# Access Compliance Report

## Public Rights-of-Way

### (Pedestrian Signals)

Intersection ID: N/A	Main Street:	Cross Street: N/A	Location: N/A
ADA ID: FCF8C8CAF0FC	Signal Type: One Push Button-Non APS	Overall Compliance: No	Severity Score: BTN 1: N/A BTN 2: N/A No BTN: N/A
Codes/Mitigation Info/Possible Solution		Field Measurements/Component Compliance

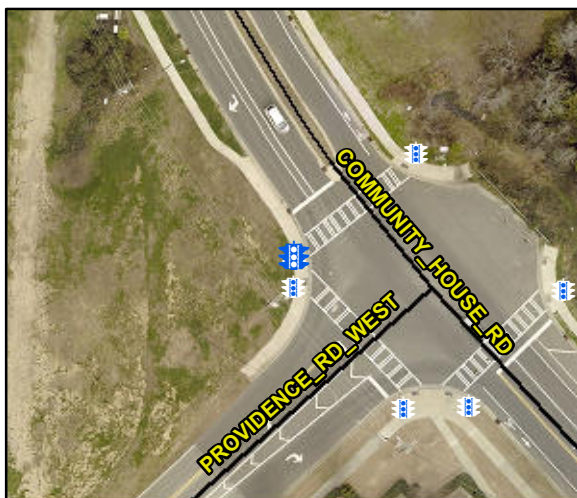
PROW/ADA: TMUTCD 4e.08

Yes	B 1 Clear Xing Direction?	ClearlyMarked	N/A	B 2 Clear Xing Direction?	N/A
	B 1 Crossing Direction	To NE		B 2 Crossing Direction	N/A
Yes	B 1 DistanceTo XWalk (in)	0.0	N/A	B 2 DistanceTo XWalk (in)	N/A
No	B 1 DistanceTo Curb (in)	88.0	N/A	B 2 DistanceTo Curb (in)	N/A
Yes	B 1 Diameter (in)	2.0	N/A	B 2 Diameter (in)	N/A

Possible Solutions: Replace Signal Push Button With APS Button on New Post. Remove & Relocate Sign.
